<b>Rapiscan</b> systems	<b>Secure 1000 Radiation Emission Measurement</b>	<b>FORM R-0646-1 (Single Pose)</b>
----------------------------	---	------------------------------------

**Re: Rapiscan AIT System Radiation Survey Reporting**

## R-0646-1 Addendum (Documentation Errors)

Product Name	Secure 1000SP (Single Pose)
Serial Number	<b>S51039006</b>
Radiation Emission Measurement	Radiation Survey Dated: 11/12/2010
RSO Initials	[REDACTED]

**2. Radiation Leakage Measurement: Survey Table. 2**

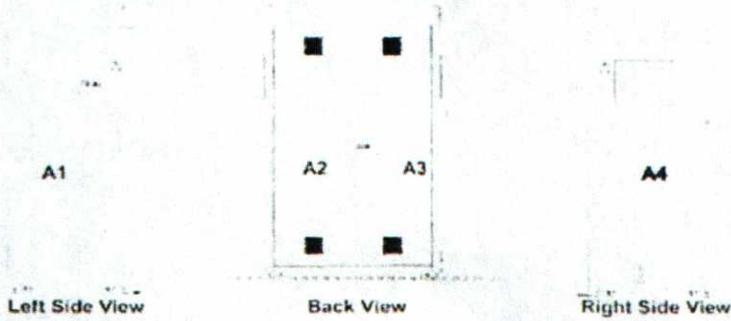
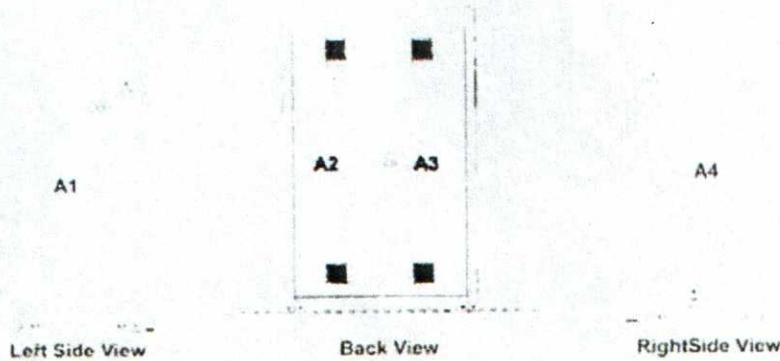
1. No value indicated for background radiation. Typical values range from 7uRem/hr to 13uRem/hr at sea level. Note: Absence of value has no adverse impact on calculations.
2. Technician indicated scan time as 7 seconds. Correct scan time is 3 seconds.
3. TABLE 2: Data in Column 3 Location A4 is missing.
4. TABLE 3: Incorrect presentation of data in Column 3 for Measured Exposure. Indicated value is .1 uRem. The correct value should be 1 uRem.
5. TABLE 3: Incorrect presentation of data in Column 6 for Dose Equivalent. Indicated value is .18 uRem. The correct value should be 1.8 uRem.

The service technician should attend refresher training.

The corrected data indicates this system was operating within expected parameters. No re-survey is required for this system.
